**Planning Department
Transportation Development Services**

**Re: Sandia Area Federal Credit Union, 11301 Montgomery Blvd. NE
Traffic Circulation Layout
Plan Dated 02-04-15 (F22-D002)**

TRAFFIC
CIRCULATION
LAYOUT

Site plan

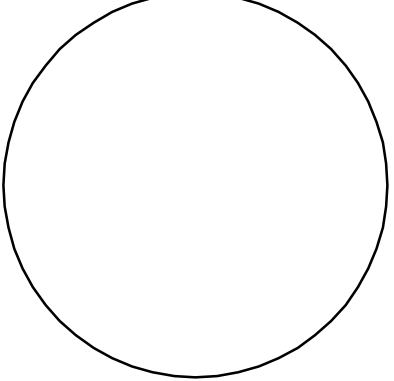
1. The proposed development looks like it may meet the threshold for a Traffic Impact Study based upon the combined square footage of the Sandia Area Credit Union building and the Starbucks. Provide a trip generation.

2. Please provide a zone atlas number for the vicinity map.
3. For the next submittal, provide the details for the curb, pavement section for the parking lot, handicapped ramp, and handicapped parking spot signage.

4. Identify adjacent street widths and right-of-way widths for Montgomery Boulevard and Cairo Drive. List the existing sidewalk widths for both streets.

5. Remove and replace the ramp on the northwest corner of the Cairo Drive/Montgomery Boulevard intersection to comply with more current ADA standards, and include the truncated domes. Design the ramp so that pedestrian traffic can easily access it across Cairo Drive and across Montgomery Boulevard. Construct the ramp around the existing mastarm using header curb so that you will not have to relocate it.

6. Remove the handicapped parking spot signage within the Cairo Drive right-of-way that is being unused.
7. Show where new on-site curb begins and ends. Differentiate between existing and new curb. It would be easier to show a different legend for the existing curb. Replace the existing ramps at the access off of Montgomery Boulevard to match current ADA standards and include the truncated domes.

8. For Keyed Note 3, call out the necessary COA Standard Dwg. Number. Call out the necessary COA Standard Dwg. Numbers for any work within COA right-of-way as applicable. Be sure to include truncated domes for the curb ramps at the access off of Cairo Drive.

9. For curb called out for Keyed Note 23, show all curb radii. Show the 24-foot dimension width for the parking aisle on the north side of the parking lot east of the main parking aisle off of Montgomery Boulevard. Label curb radii for the access off of Montgomery Boulevard, even if this is meant to be existing and left alone.

10. List length of queues for both the credit union and the Starbucks. Show both the overall length and how many cars can be accounted for.
11. For the credit union, show widths of aisles in between the concrete islands called out in Note 11. Also, show striping for delineation between these aisles north of the islands for a certain distance until the drive necks down.

12. Provide a 6-foot wide ADA accessible connection from Starbucks to the existing street right-of-way. It is required to have a 6-foot ADA accessible pathway from the public right-of-way to the building entrances.

13. Include a minimum width of 8 feet wide for both van access aisles. The ADA van accessible sign must have the required language per 66-7-352.4C NMSA 1978 **"Violators Are Subject to a Fine and/or Towing."** Include an accessible signage detail for the next submittal showing this language.

14. The words **"NO PARKING"** for each of the van accessible aisles should be at least one foot high and at least two inches wide. Call out these dimensions within a keyed note.

15. A design delivery vehicle route needs to be shown from the public right-of-way and through the parking lot for the two new facilities.
16. "Do Not Enter" signage is required at the end of the driving aisles for the drive-thrus at both on-site facilities.

17. The wheelchair ramp called out by Keyed Note 29 needs to have a minimum 4 foot by 4 foot level surface landing at the top of the ramp for wheelchair turning.

18. Please provide a sight distance exhibit for the drive onto Montgomery Blvd. (see the *Development Process Manual, Chapter 23, Section 3, Page 23-28, Part D.5 Intersection Sight Distance*).

19. Please add the following note to this clear sight triangle: "Landscaping and signage will not interfere with clear sight requirements. Therefore, signs, walls, trees, and shrubbery between 3 and 8 feet tall (as measured from the gutter pan) will not be acceptable in this area."

20. For the drive on to Cairo Drive, provide a mini clear sight triangle as per Page 23-74 of the Development Process Manual. For this location, also add the following note to this clear sight triangle: "Landscaping and signage will not interfere with clear sight requirements. Therefore, signs, walls, trees, and shrubbery between 3 and 8 feet tall (as measured from the gutter pan) will not be acceptable in this area."
21. For required spaces of between 36 to 50 spaces, 3 accessible parking spaces are required (NMBC Table 1106.1). Therefore, a total of 3 spaces would be required for Starbucks, and 3 spaces would be required for the credit union.
22. Please submit two copies of the Traffic Circulation Layout for the next submittal.
